**STS-114 ET Vent Arm Umbilical Purge Shroud IFA Closure
Rationale, STS-114-I-014
&
Update ISPR-02
“ET Vent Arm System (ETVAS) Umbilical System
Malfunction”**

**CR# S050425DG
SICB**

“ET Vent Arm System (ETVAS) Umbilical System Malfunction”

CR# S050425DG

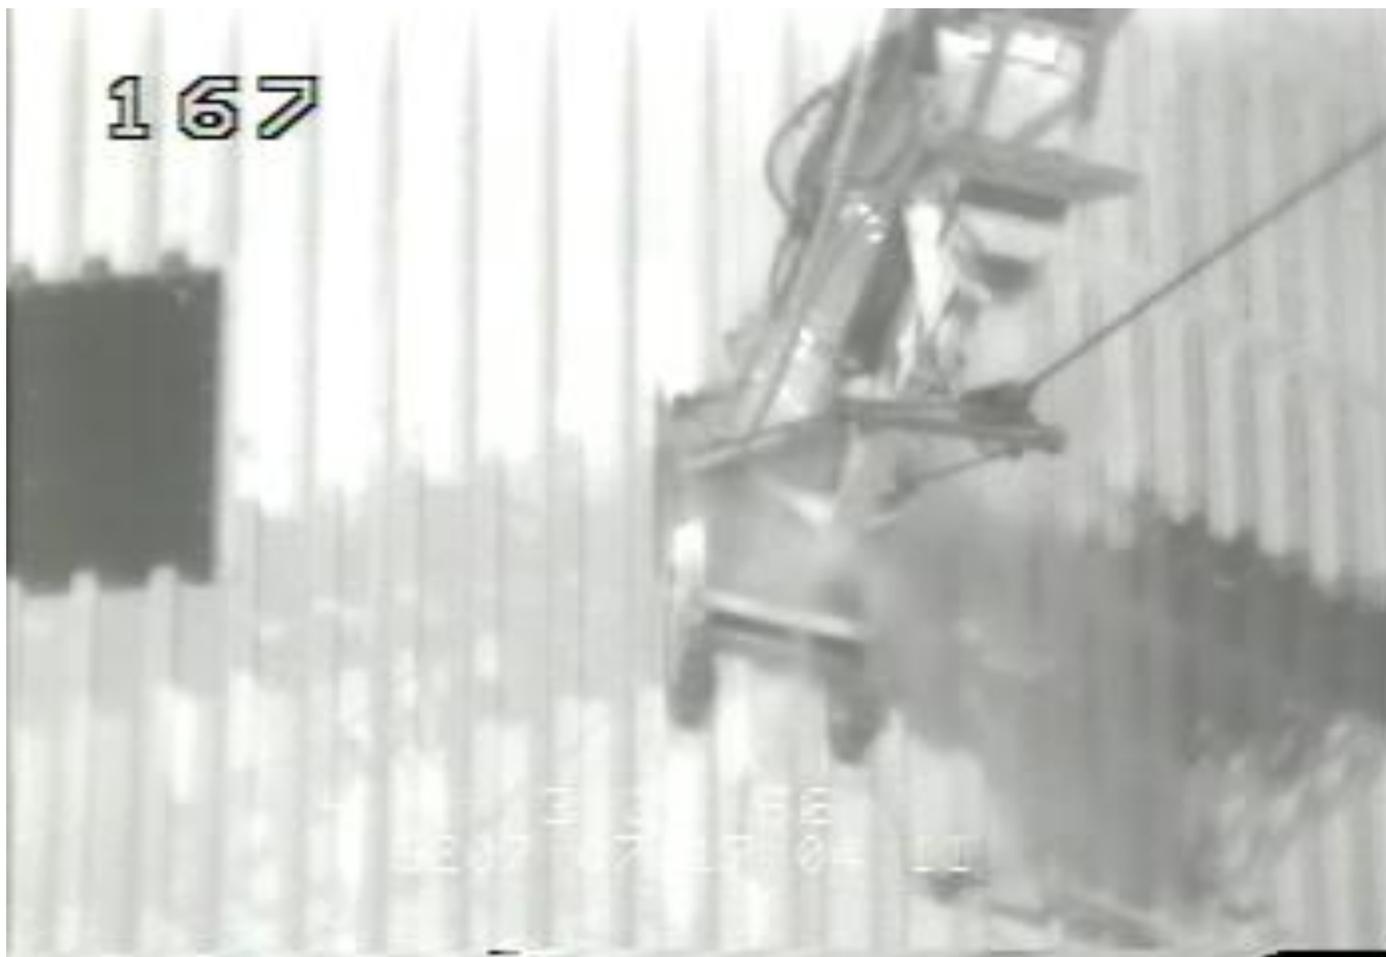
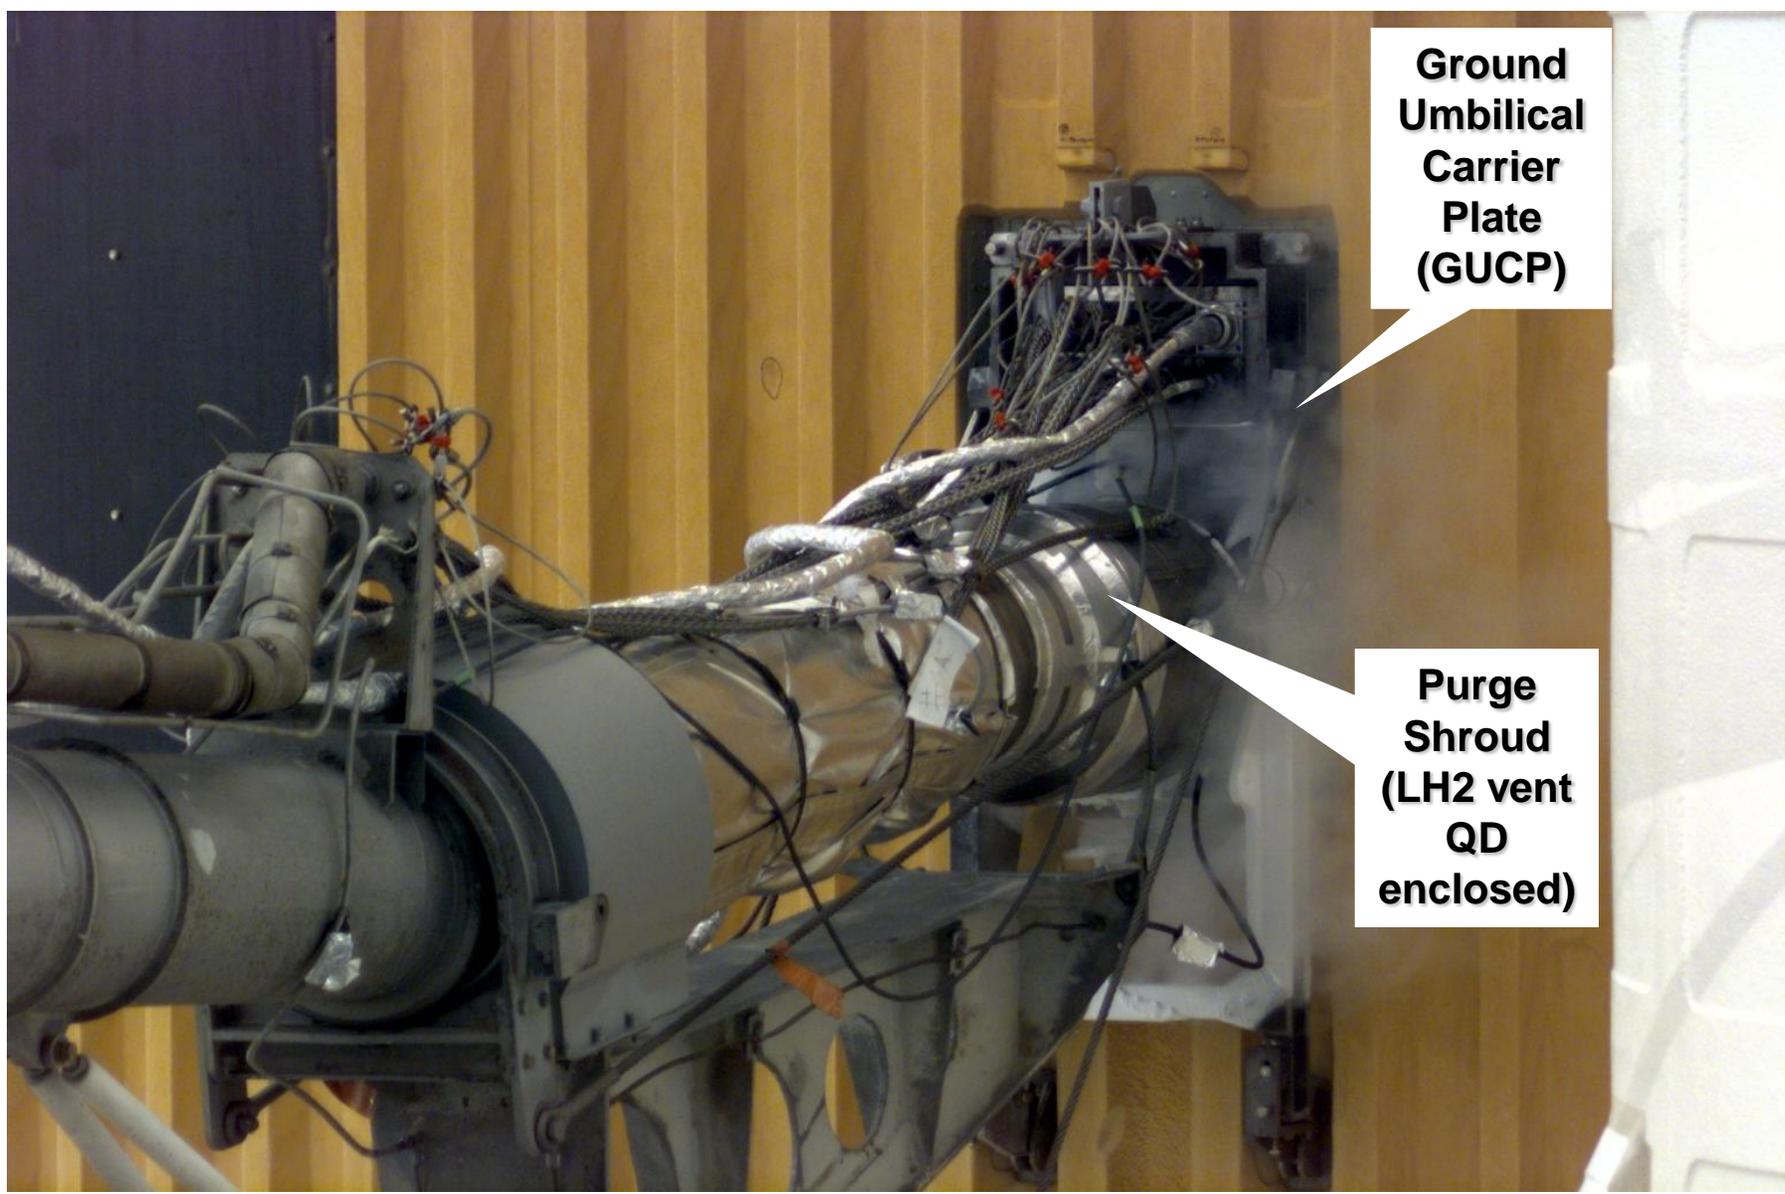
- Excessive frost/ice at the GUCP to ice suppression shroud interface was noticed during tanking test #2 (reference IPR 114V-0361).
- During the STS-114 launch attempt on July 13, 2005, cryogenic liquid was seen flowing from the bottom of the GUCP ice suppression shroud starting at LH2 replenish when the LH2 vent QD is the coldest
- Ice was observed on the bottom of the shroud at the seam between the purge can halves
- During the STS-114 launch on July 26, 2005, the same problem was noted (reference IPR 114V-0472).
- IFA STS-114-I-014, LN2 DRIPPED FROM ET VENT LINE ICE SUPPRESSION SHROUD, assigned to KSC Integration (MK-SIO)
- LN2 liquefaction did not cause anomalies to SSV elements.
- Lien placed against ISPR-02 for LN2 Liquefaction

- LN2 Dripping onto SSV TPS, EB-3 and EB-7 attach points

GH2 Vent QD Shroud Cut-Away (suspected leak pattern)

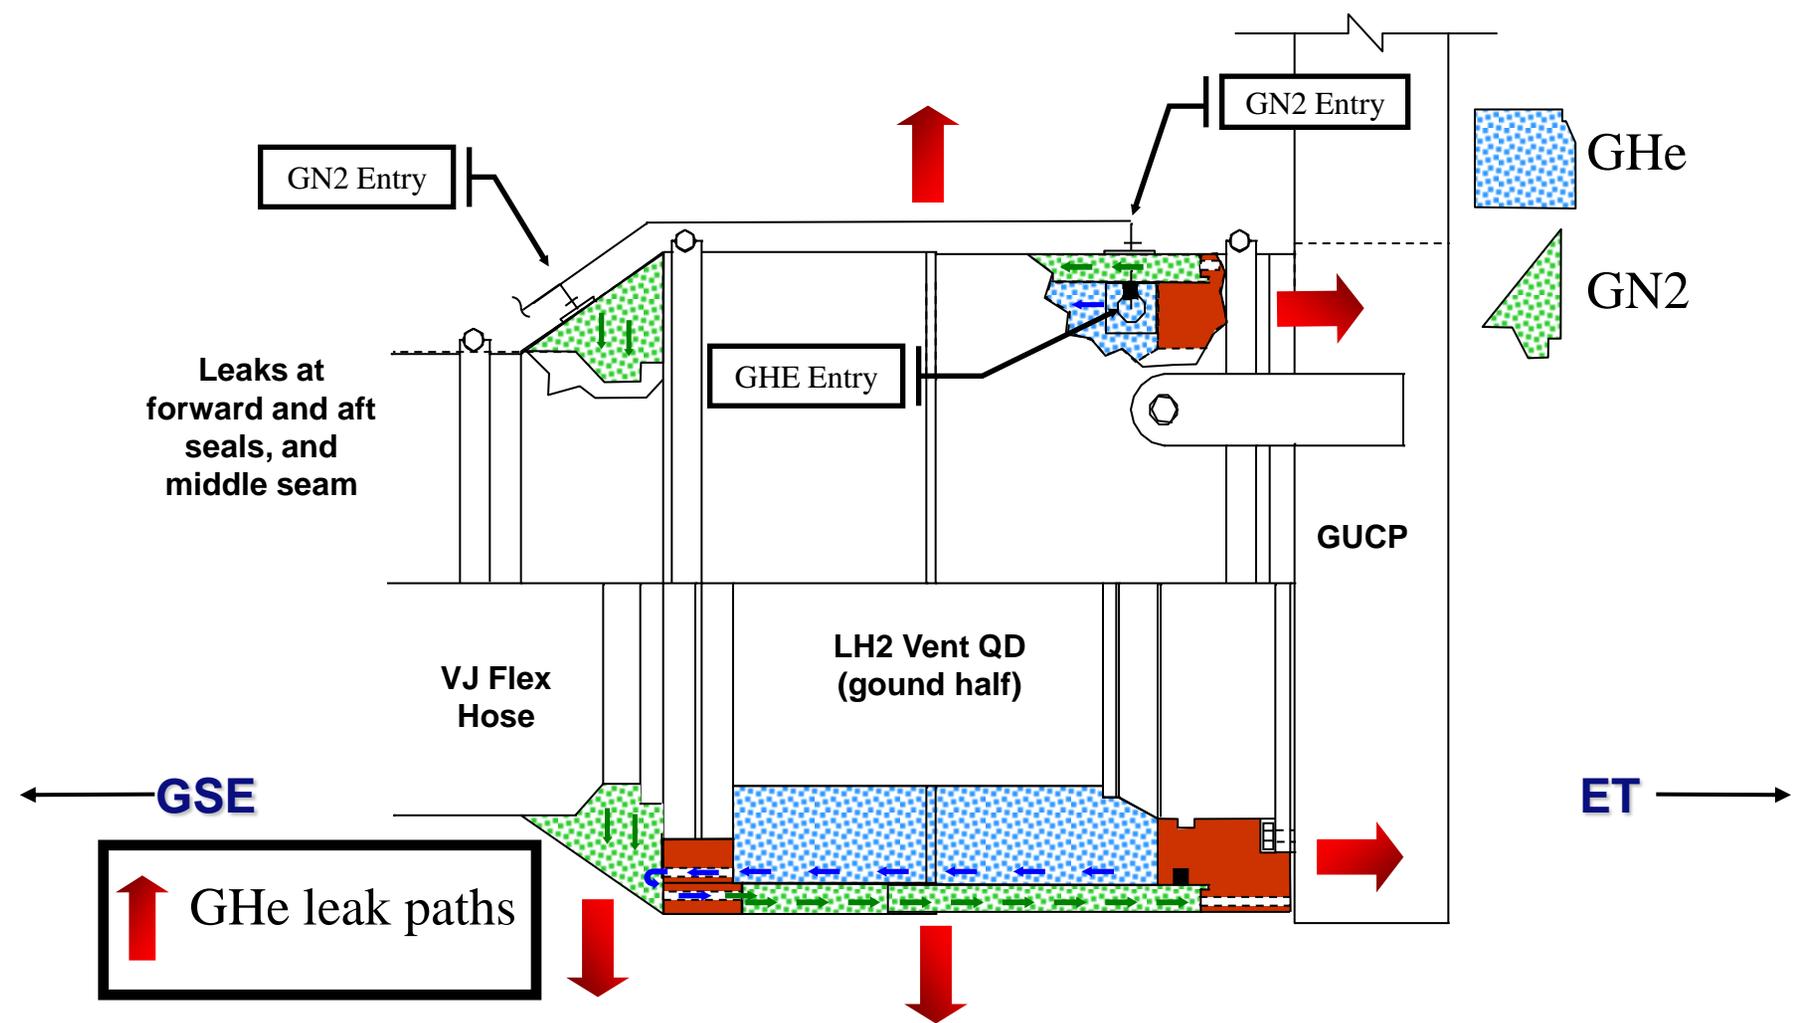
Cause of LN2 formation

- (reference figure next page)
- Gap between the LH2 vent QD and the phenolic ring at the GUCP interface allowed venting of GHe
- GN2 intrusion into the inner cavity due to evacuating GHe
- The GN2 liquefy's due to contact with the LH2 Vent QD.

GH2 Vent QD Shroud Cut-Away
(upper half detail)

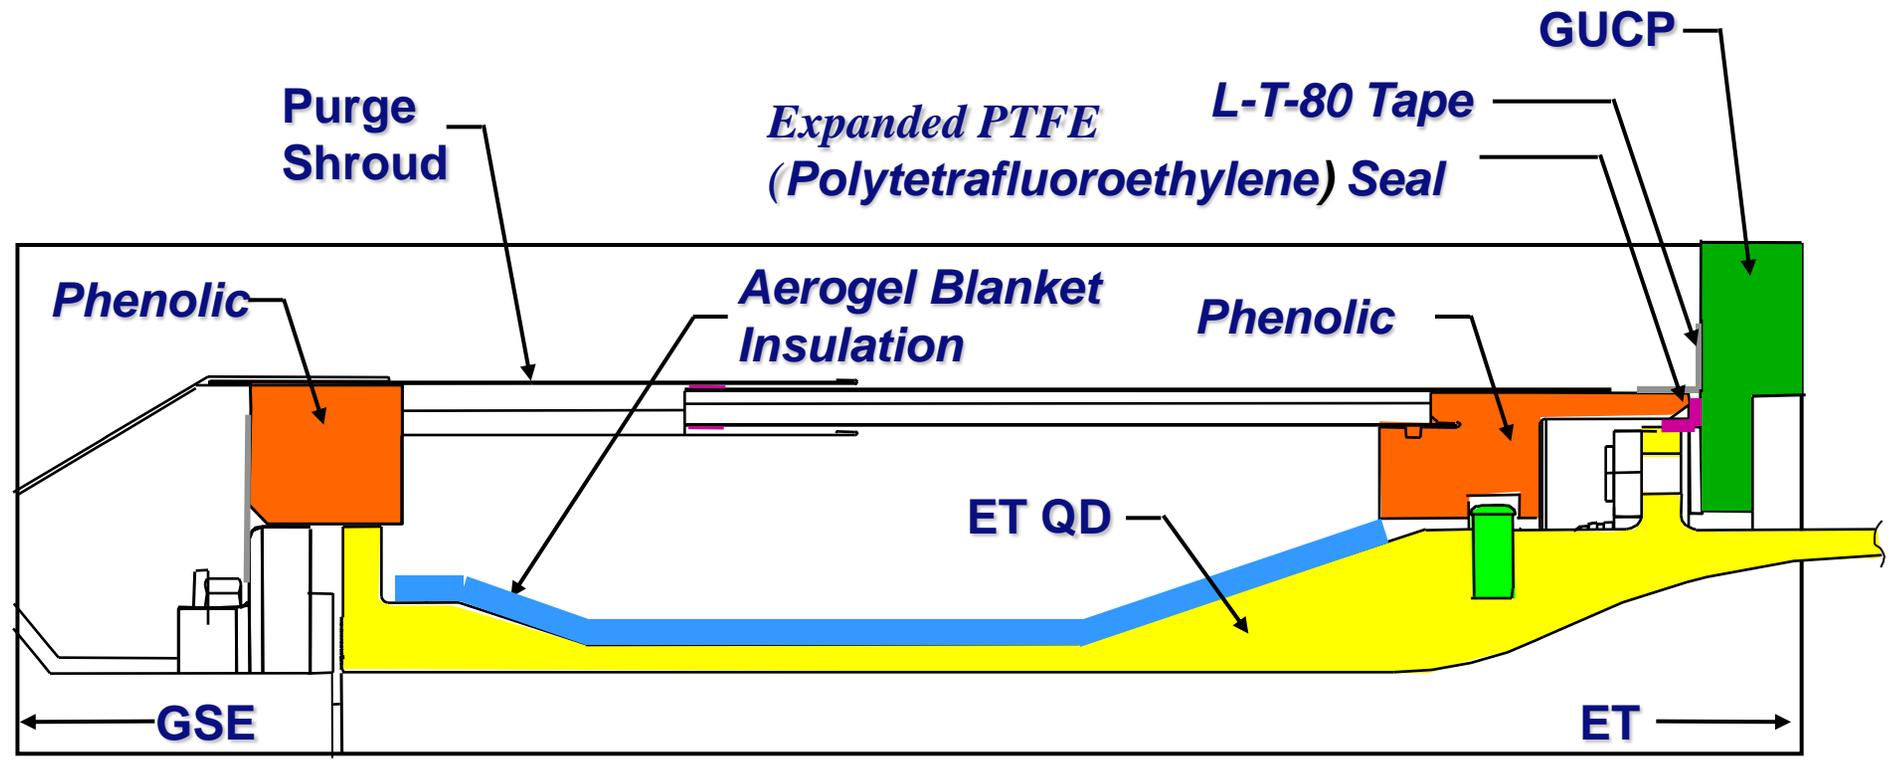
Modification of GH2 Vent QD Purge Shroud

- Figure showing new components (*italics*)

GH2 Vent QD Shroud Cut-Away

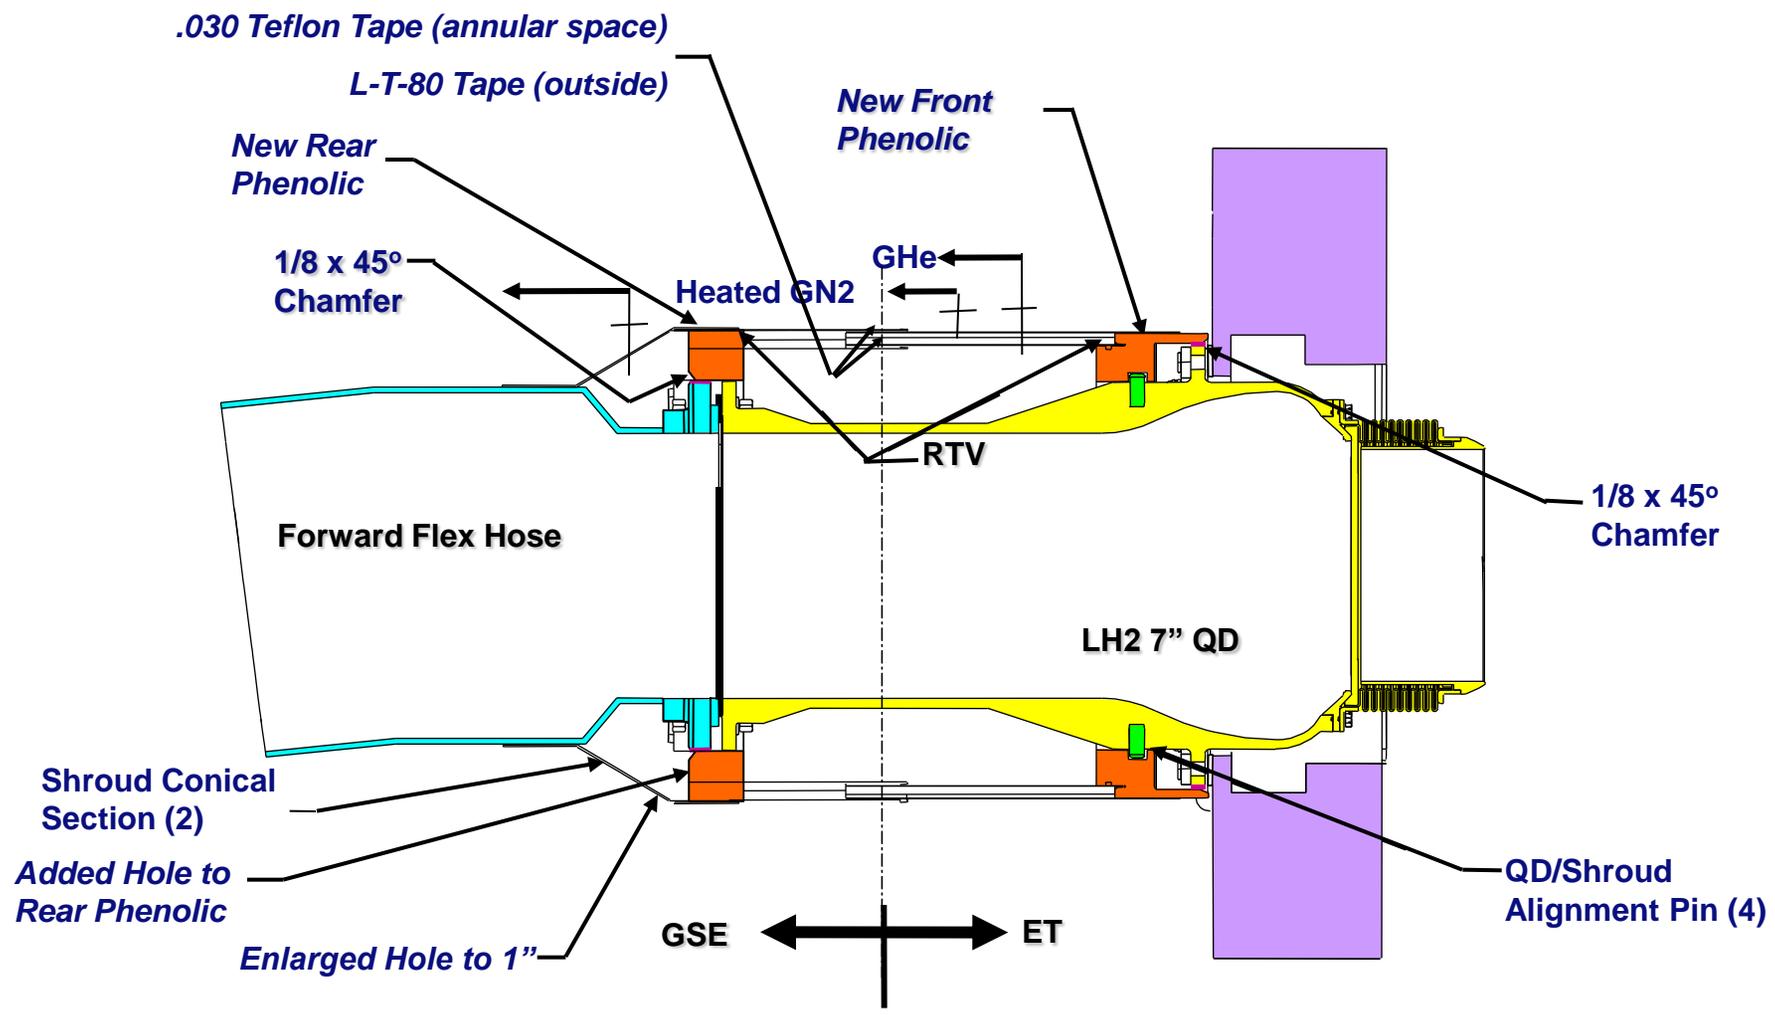
Modification of GH2 Vent QD Purge Shroud

- Figure showing new components (*italics*)

- Qualification testing is complete and successful at the KSC Launch Equipment Test Facility using LH2.
 - No frost formation on the shroud
 - No LN2 formation produced during testing.
